SERVICE BULLETIN

SB-10057784-1093 April 13, 2015

PRODUCT PROGRAM 0919: 2015 STREET MODELS RIGHT SIDE RIDER FOOT CONTROL MOUNTING SCREWS

Figure 1. Right Side Rider Foot Control Assembly

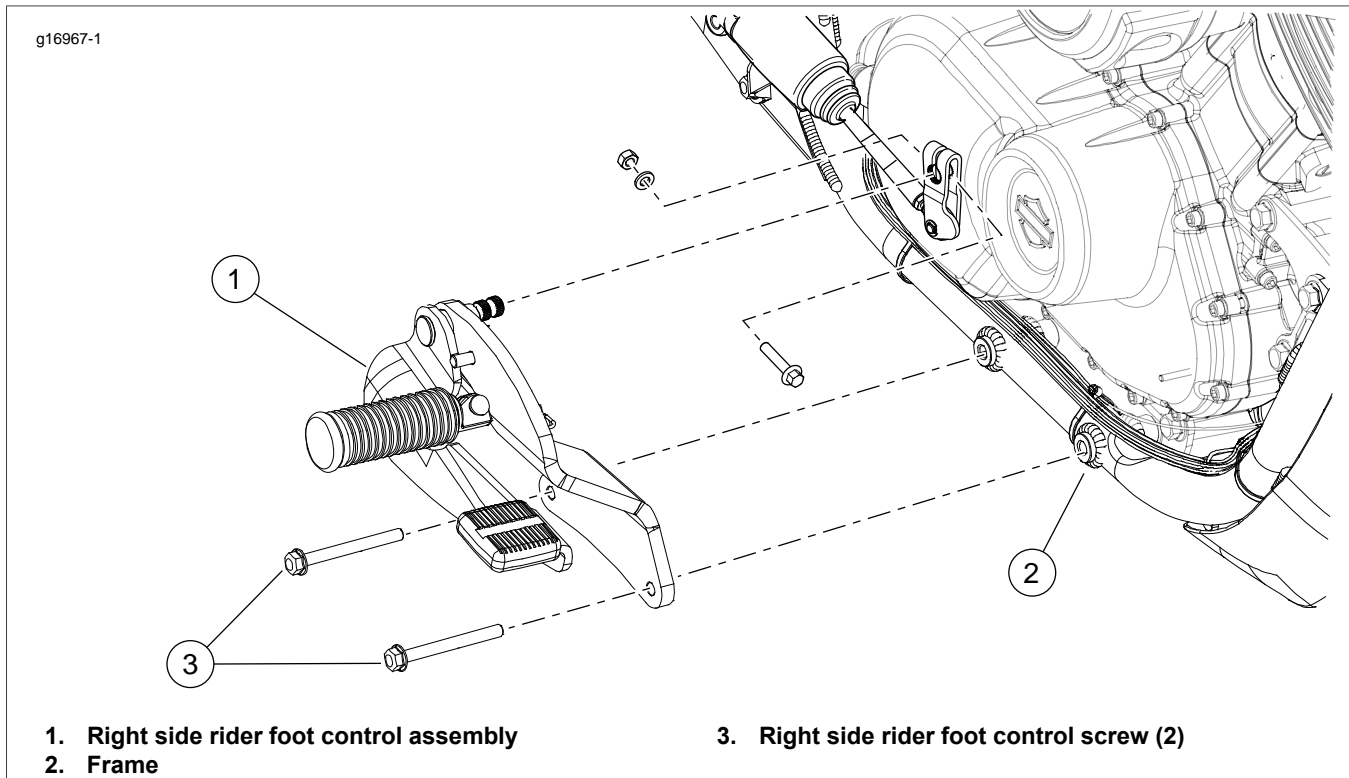
2. See Figure 1. Loosen both right side rider foot control mounting screws (3).

3. Retighten screws to 22.0-29.0 Nm (17-21 ft-lbs).
